ADDENDUM NO. 1

Project: City of Dyersville–Delaware County
RM-2160(618)--9D-31
20 West Industrial Center
Phase 3
Contract D – Storm Sewer, Paving and Lighting

Project No.: 21249

Issue Date: April 22, 2024

PCC PAVEMENT

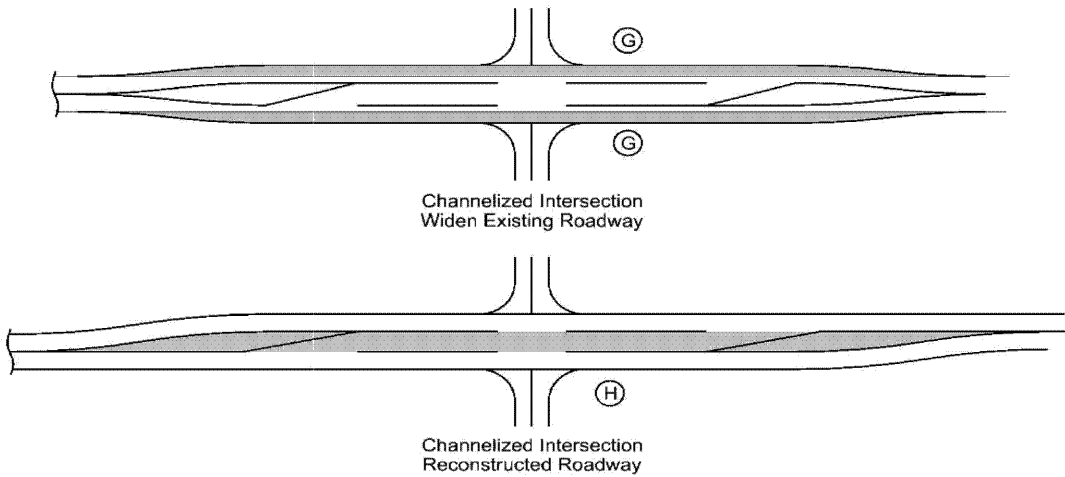
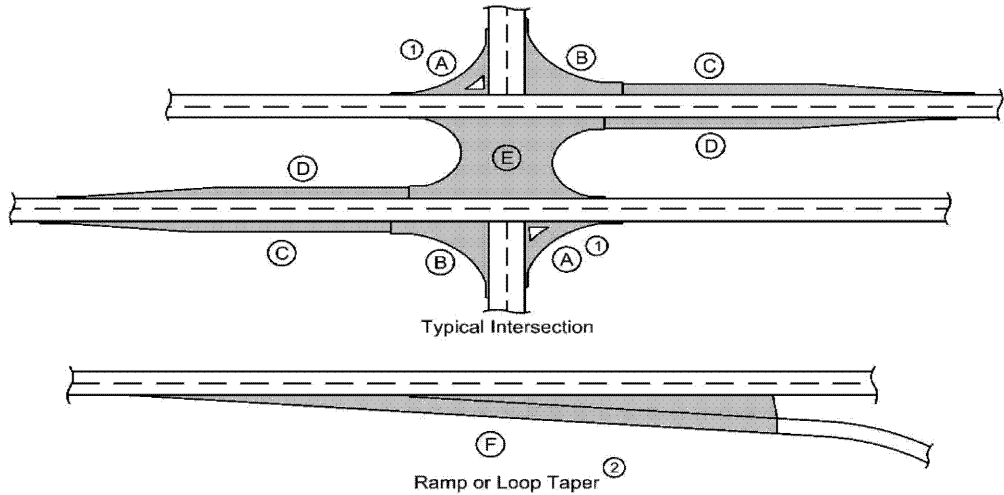
1. Sheet B.1, Added alternate typical street section 18/B.1.
2. Sheet C.1, Modified additive alternate 1 paving extension estimated project quantities table.
3. Sheet C.2, Modified additive alternate 1 paving extension estimate reference table.
4. Sheet C.4, Modified PCC pavement table to reflect new 8" PCC and modified subbase quantities for alternate 1.
5. Sheet D.1, Revised notes to reflect 325' alternate 1 paving section change to 28' wide PCC rural section following current graded profile to match in with existing 320th Ave current profile.

Location				Mainline			Area (3)								Total Area By Pavement Thickness	Special Backfill	Modified Subbase 6"	Modified Subbase 14"	Remarks
Road Identification	Direction of Travel	Station to Station		Width	Length	Area	(1)	(2)	(3)	(4)	(5)	(6)	(7)	(8)					
							A	B	C	D	E	F	G	H					
							SY	SY	SY	SY	SY	SY	SY	SY					
ALTERNATE	W & E	410+25.00	413+50.00	28.0	325.0	1011.0									1011.0		301.0		DIVISION 2 NON-RISE
TEMPORARY ROCK TURN-AROUND	W & E	413+00.00	413+50.00	43.0	50.0	238.9												92.9	DIVISION 2 NON-RISE
INDUSTRIAL PARKWAY	W & E	413+50.00	416+42.50	37.0	292.5	1202.5									1202.5		232.9		DIVISION 2 NON-RISE
INDUSTRIAL PARKWAY	W & E	416+42.50	431+50.00	37.0	1507.5	6197.5									6197.5		1200.4		DIVISION 1 RISE

ROADWAY QUANTITY TOTAL				
TYPE	DIVISION 1 RISE TOTAL	DIVISION 2 NON RISE TOTAL	DIVISION 2--TURNAROUND NON RISE TOTAL	DIVISION 2--ALTERNATE NON RISE TOTAL
8" PCC SY	6198	1203		1011
MOD SUBBASE CY	1200.4	232.9	92.9	209
